PORTLAND HARBOR RI/FS
ROUND 3B
SIDE-SCAN SONAR
FIELD SAMPLING PLAN

April 2008

Re: Portland Harbor Superfund Site; Administrative Order on Consent for Remedial
Investigation and Feasibility Study; Docket No. CERCLA-10-2001-0240
Round 3B Side-Scan Sonar Field Sampling Plan

Figure 1-1
 Portland Harbor RI/FS
 Round 3B Sampling - Side Scan Survey FSP
 Site and Vicinity Map

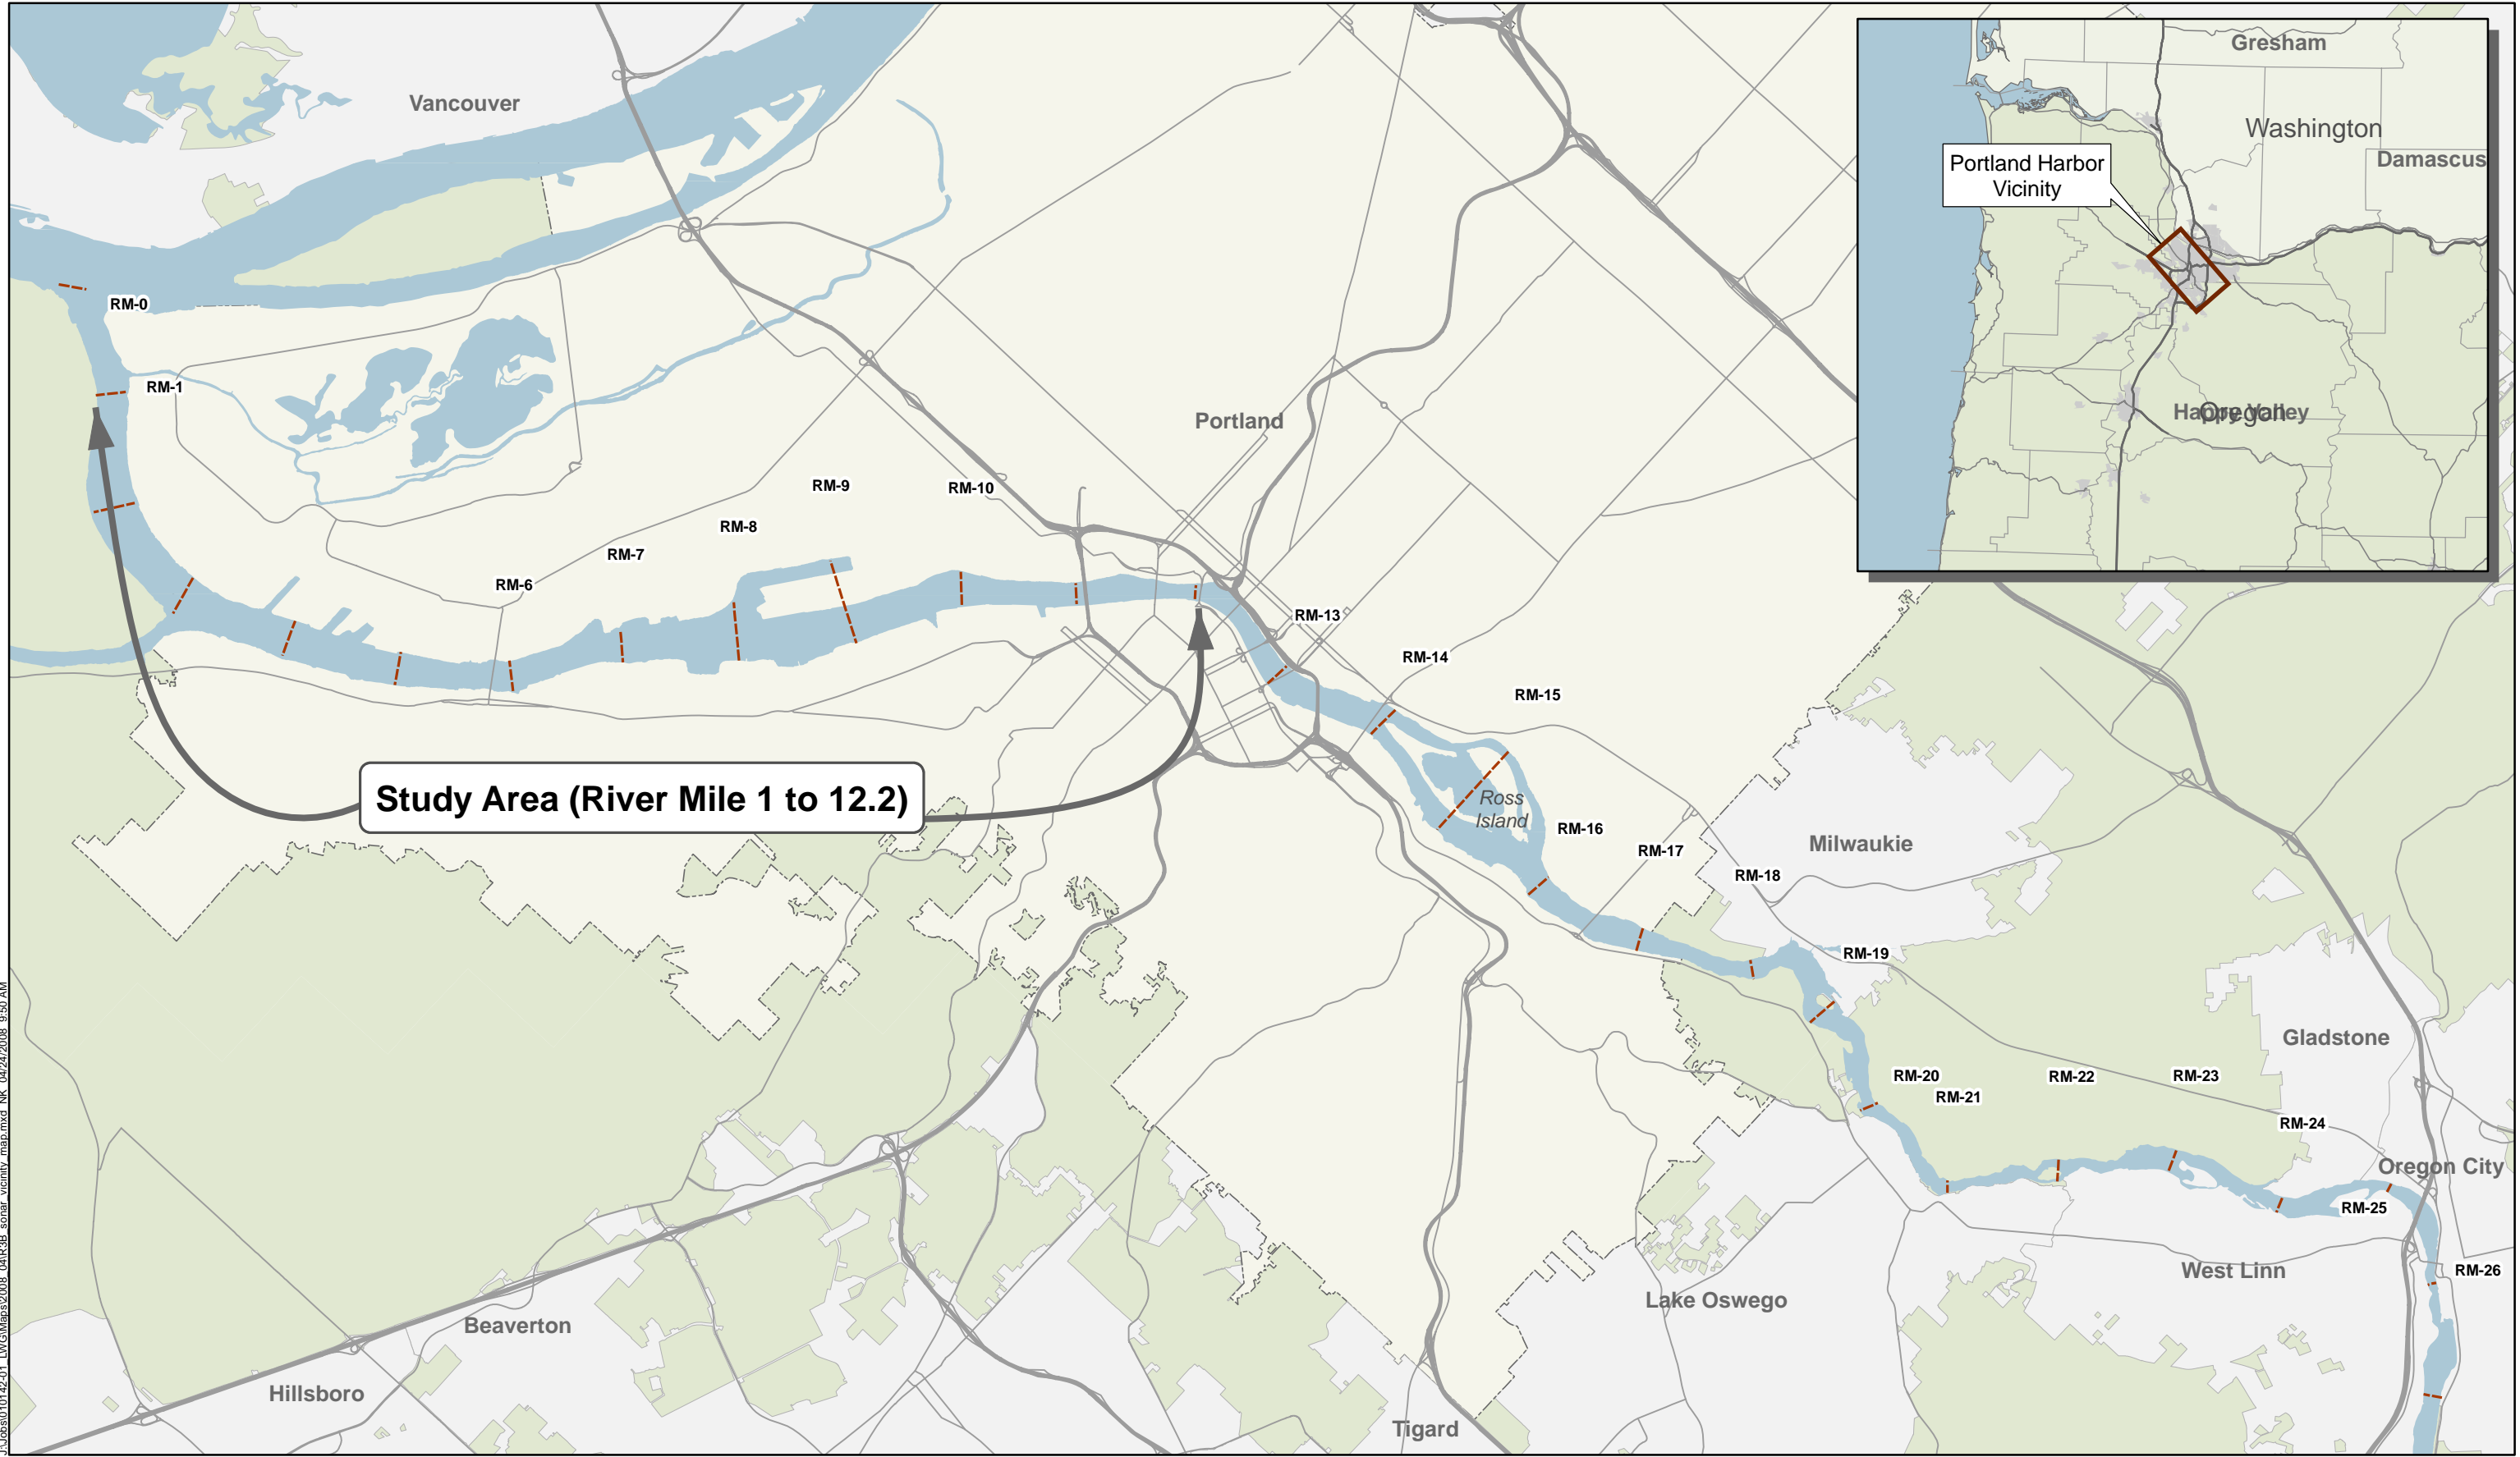
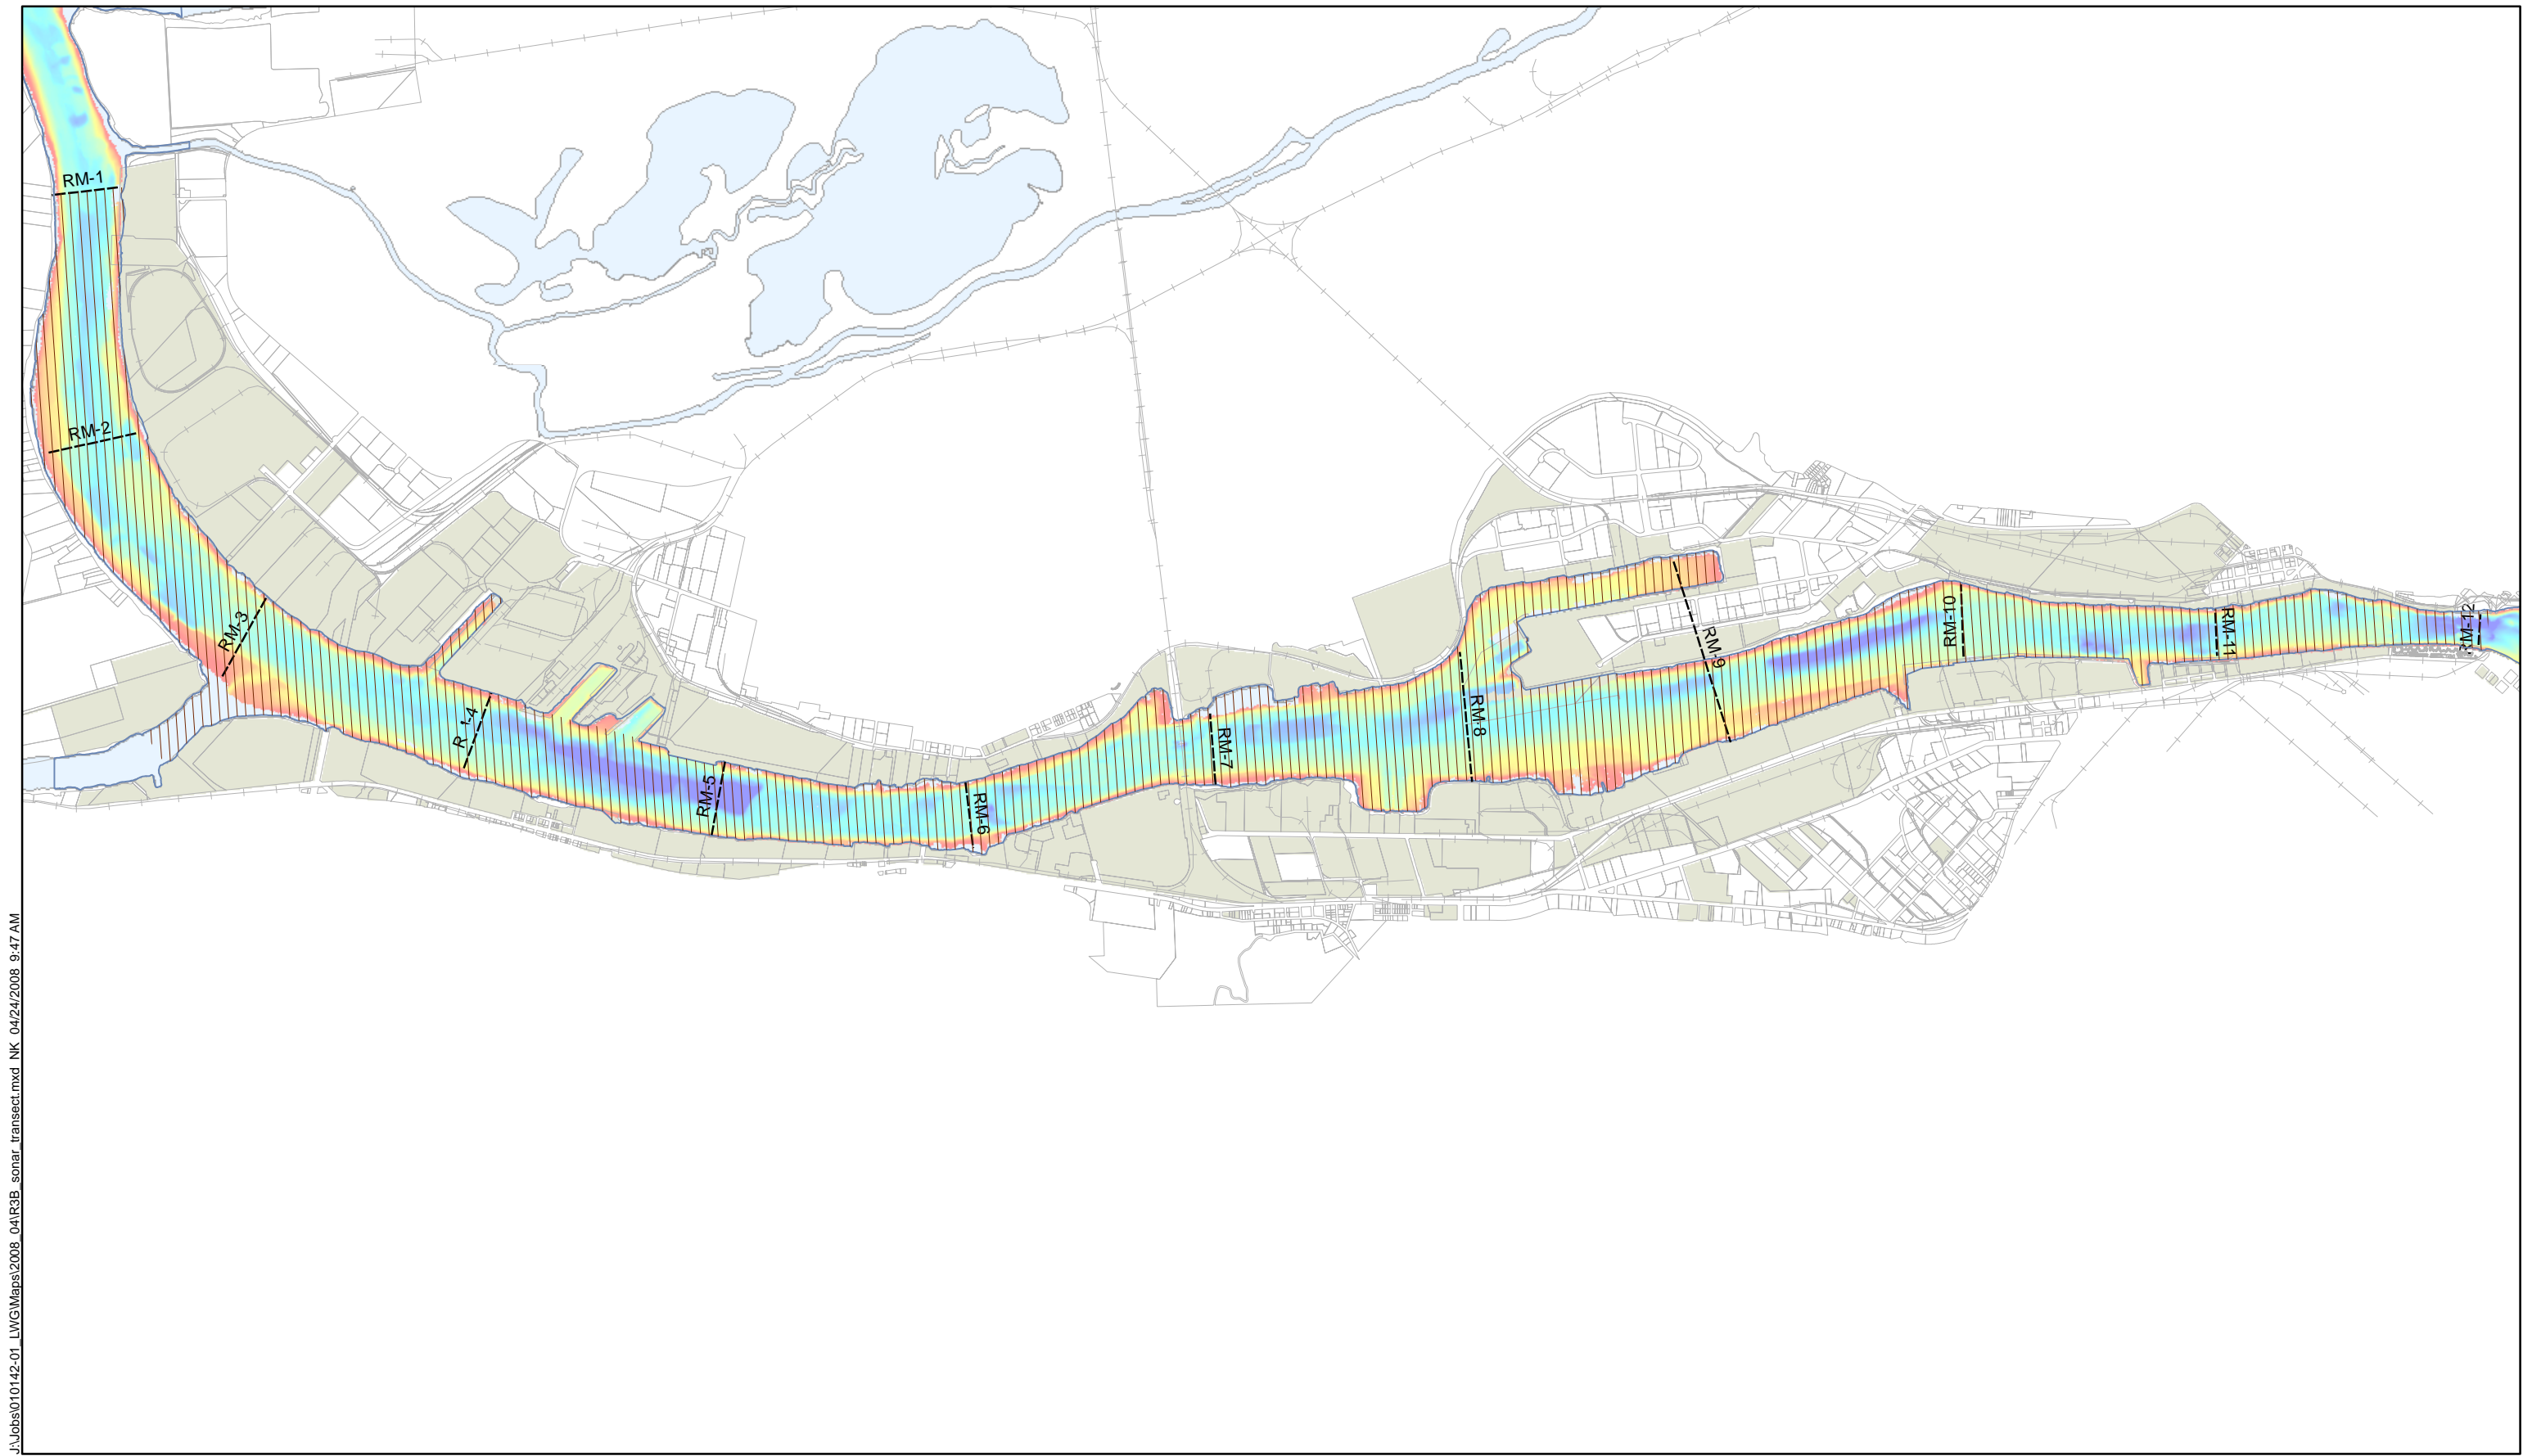
The upper boundary of the side-scan survey should be revised to RM 12.2, instead of RM 11. This should be reflected in the Figures as well.
